Prairie Island Nuclear Generating Plant

February 21, 1997 Revision to
License Amendment Request Dated July 28, 1995

Proposed Changes Marked Up
On Existing Technical Specification Pages

Exhibit B consists of existing and new Technical Specification pages with the original proposed changes and all revisions highlighted on those pages. The existing and new pages affected by this License Amendment Request are listed below:

TS.5.6-4 Spent Fuel Pool Checkerboard Region Burnup and Decay Time Requirements - STD Fuel, No GAD

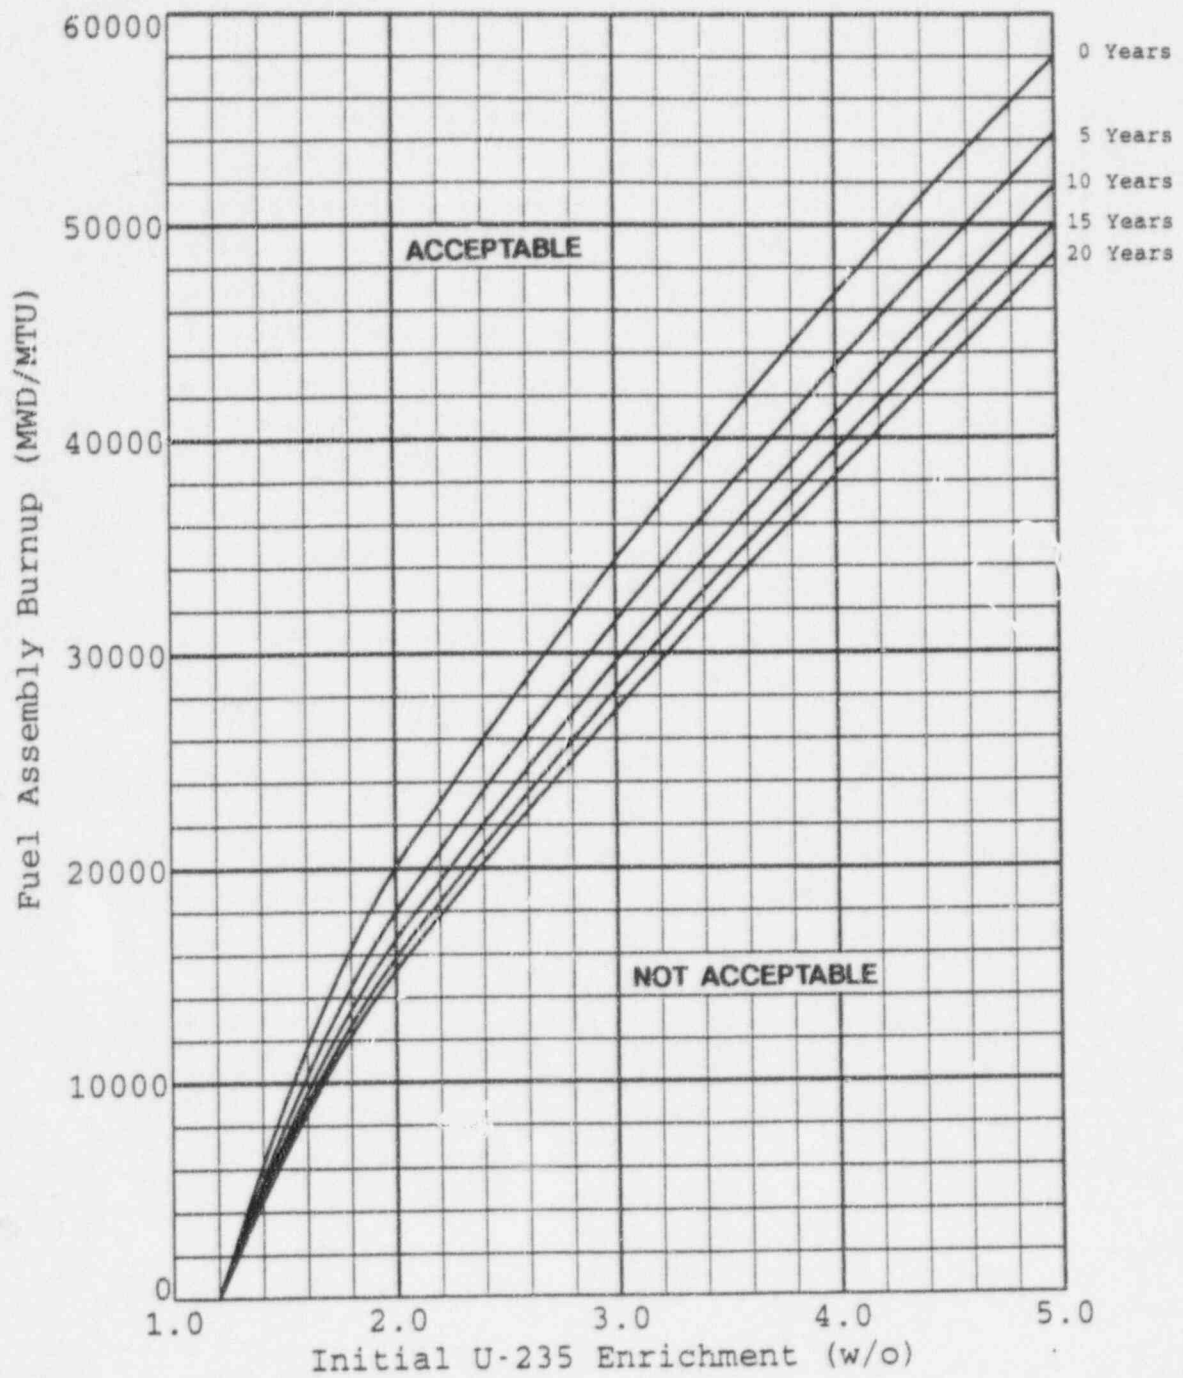
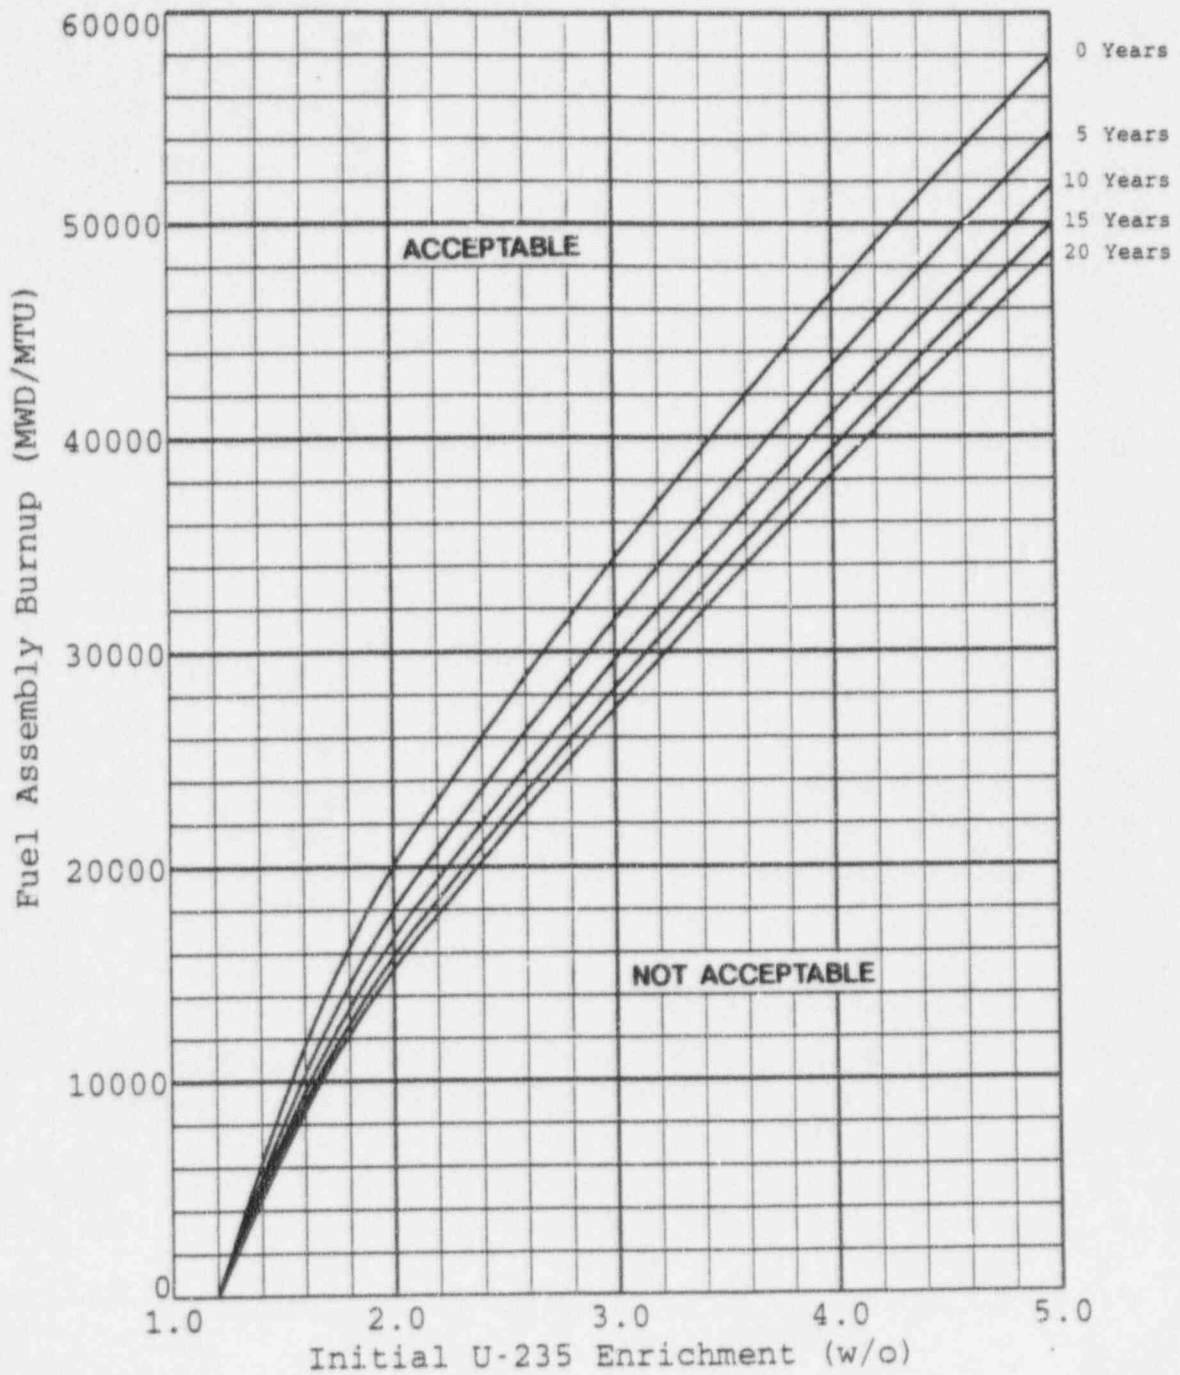
- de. New or spent fuel assemblies with a combination of discharge burnup, ~~and~~ initial enrichment and decay time in the restricted range of Figures TS.3.8-1 or TS.3.8-2, as applicable, will be stored in compliance with Figures TS.5.6-1 ~~and~~ through TS.5.6-212.

- e. New or spent fuel assemblies with a combination of discharge burnup, initial enrichment and decay time in the restricted range of Figures TS.3.8-1 or TS.3.8-2, as applicable, will be stored in compliance with Figures TS.5.6-1 through TS.5.6-12.
